Groundwater Transfer Review Summary Form

Transfer/PA # T- 13563

Ground Water Review Form:

Application: T-13563 Applicant Name: ACMPC Oregon 2, LLC (dba Halls Ferry Farms)

Figure 2. Change in groundwater interference associated with moving 0.59 cfs of Certificate 79879 from POLK 2878 to POLK 54272 ranges from 0.25 to 4 feet.

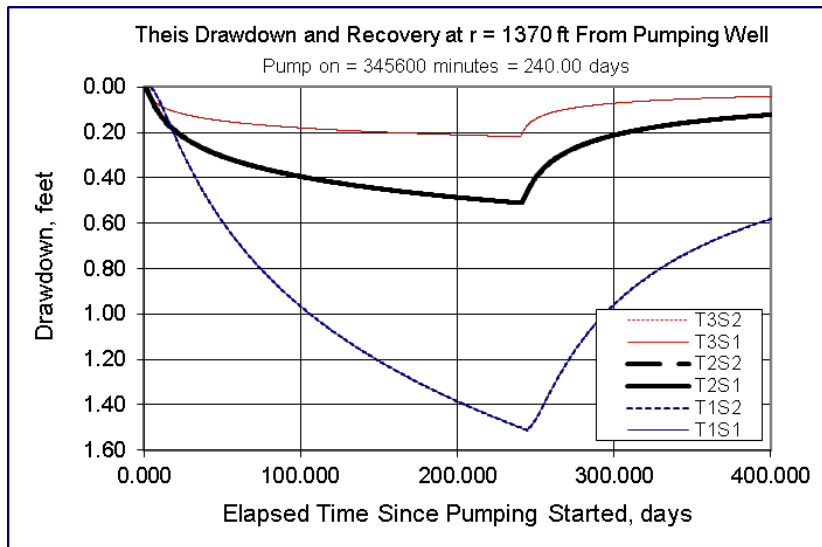
Certificate	Authorized POA(s)	Proposed Changes	Increase GW interference?	Prevents GW access?
79879	POLK 2878	Add POLK 54272/Well 27	yes	No, see Fig.2
		Add POLK 51391/Well 22	no	no
67321	4 surface water PODs	Add NLOG/Well 28	yes	No, Fig. 5
37342	POLK 2190	Add POLK 53561	yes	No, Fig. 7
		Add NLOG/Well 28	n/a	n/a
95332	POLK 2880/Well 3	Add POLK 54272/Well 27	yes	No, Fig. 9

☐ Yes ☒ No If yes, explain: Drawdown estimates between a single pumping well and a conservatively close neighbor indicate well to well interference are estimated (see figures detailing each proposed transfer). Water level elevations in the subject wells indicate a reasonably efficient, fully penetrating well could accommodate this degree of drawdown and still access groundwater. Aquifer parameters used in the Theis drawdown modeling are associated with Conlon et al. (2005) Upper Sedimentary Unit.

Figure 4. Stream depletion of Rickreall Creek by pumping Well 28/no log. The degree of surface water interference does not meet the standard for surface water to groundwater transfers.

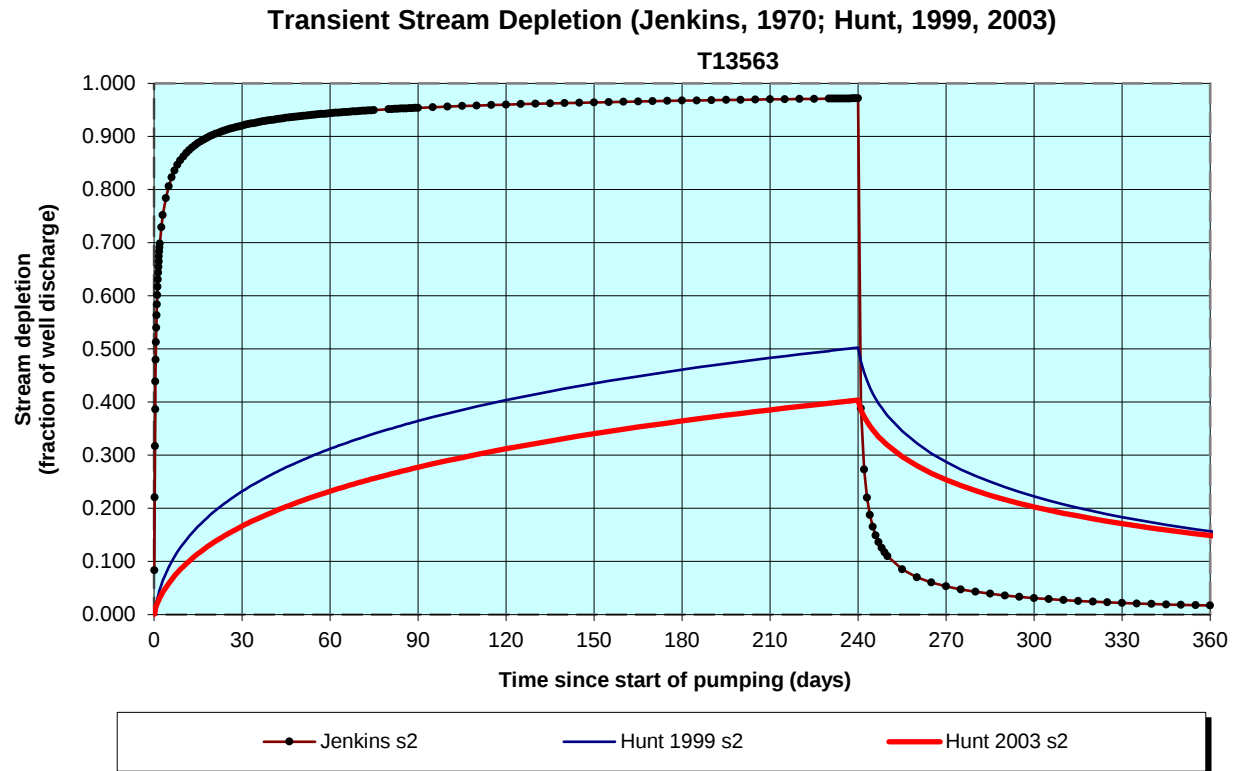
67321	4 surface water PODs	Add NLOG/Well 28	Does not meet standard, see section 5	Does not meet standard, see Fig. 4
37342	POLK 2190	Add POLK 53561	no	n/s
		Add NLOG/Well 28	n/a	n/a
95332	POLK 2880/Well 3	Add POLK 54272/Well 27	no	n/a

5. For SW-GW transfers, will the proposed change in point of diversion affect the surface water source similarly (as per OAR 690-380-2130) to the authorized point of diversion specified in the water use subject to transfer?
☐ Yes ☒ No Comments: The change proposed to Certificate 67321 is the only surface water to groundwater transfer. As shown in Figure 4, stream depletion (estimates made with Hunt, 1999) does not meet the standard of 50% of pumping after 10 days of pumping. Additionally, there is no well log for Well 28, so this review cannot determine that the well meets current minimum well construction standards. This well was denied a groundwater permit in part because of the lack of well construction records for Application G-18552.
6. What conditions or other changes in the application are necessary to address any potential issues identified above: none
7. Any additional comments:

Figure 5. Change in groundwater interference for moving 0.99 cfs of Certificate 67321 from a surface water diversion to Well 28 (which has no well log).

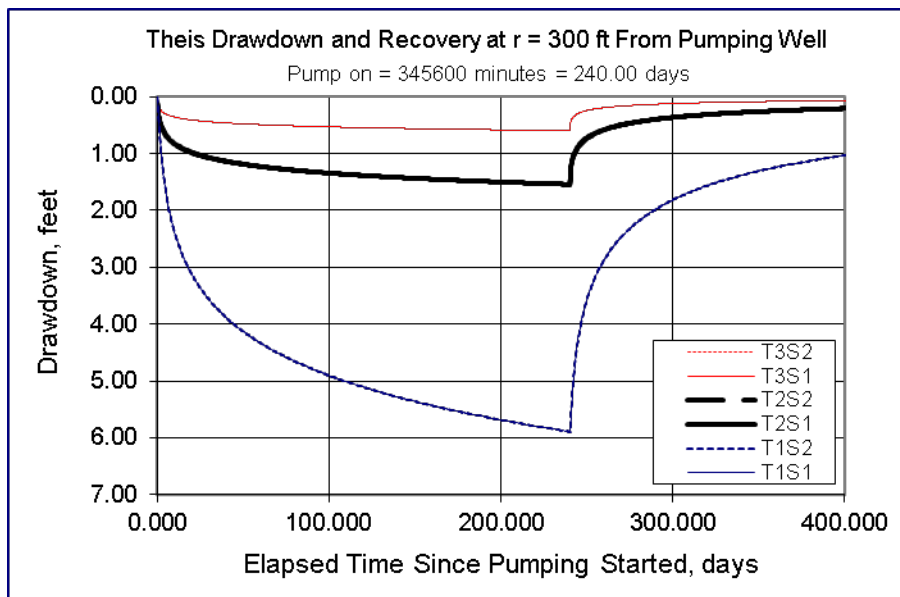
- ☐ The water well reports provided with the application do not correspond to the water rights affected by the transfer.
- ☒ The application does not include water well reports or a description of the well construction details sufficient to establish the ground water body developed or proposed to be developed. This comment is limited to Well 28, which is a proposed APOA for Cert 67321.
- ☐ Other _____

Figure 10. Cumulative drawdown from irrigating 300 acres solely from POLK 54272 with pumping rate normalized to 3 AF/acre over 240 days. This is a cumulative result of the changes proposed to Certificates 79879 and 95332 in addition to T-13567, T-13568, T-13569.

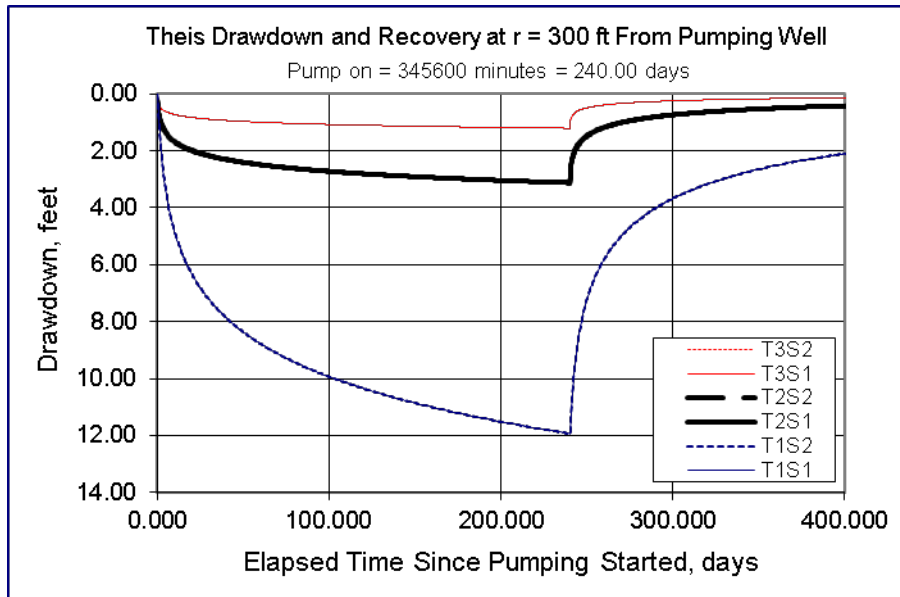
Changes to Certificates 95332 (0.28 cfs) and 79879 (0.59 cfs) propose transferring an unspecified portion of the water rights to POLK 54272. GR Modifications are also under review (T-13567, T-13568, T-13569) that propose to transfer use to POLK 54272 for a total possible rate of 4.212 cfs (total of 300 acres of primary irrigation). POLK 54272 is located in close proximity (within 300 feet) to at least 3 wells, and the cumulative impact of a new pumping center at this location is modeled in Figure 10. The cumulative impact of moving 300 acres of primary irrigation to POLK 54272, as proposed by the combination of changes produces a total drawdown at a distance of 300 feet ranging from 1 to 12 feet. This is not expected to prevent nearby fully penetrating and reasonably efficient wells from accessing water.

Figure 12. Cumulative drawdown from irrigating 430 acres solely from POLK 53561 with pumping rate normalized to 3 AF/acre over 240 days. This is a cumulative result of the changes proposed to Certificates 37342 in addition to T-13564, T-13565, T-135669, T-13570.

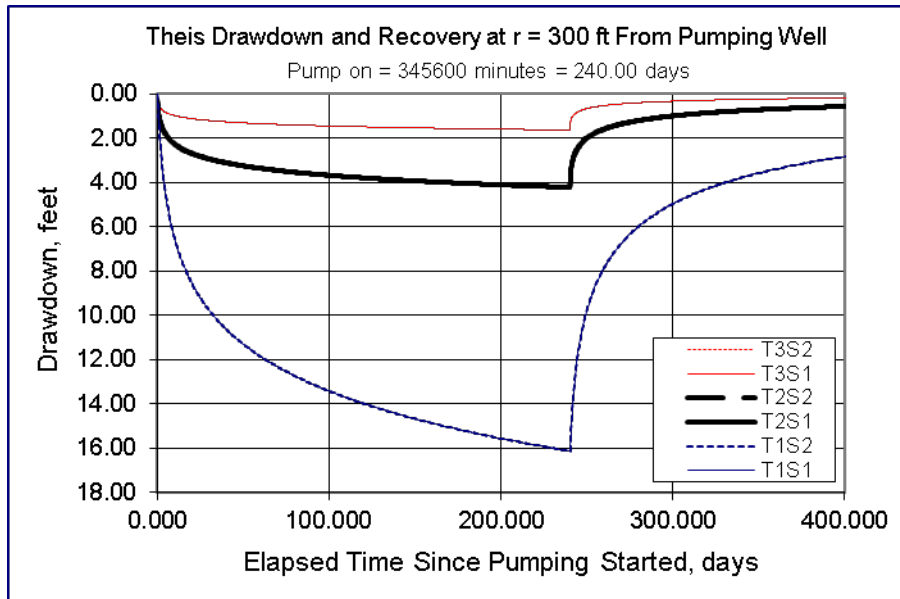
Changes are proposed to add POLK 53561 to 5 groundwater rights (Certificate 37342, GR 682, GR 683, GR 685, GR 1515) for a cumulative right of 430 acres of primary irrigation. These changes are proposed through T13563, T13564, T13565, T13566, T13570. This cumulative rate, normalized to 240 days of pumping up to 3 acre-feet per acre, is 1,216 gpm. This is not expected to prevent nearby fully penetrating and reasonably efficient wells from accessing water (see Figure 12).
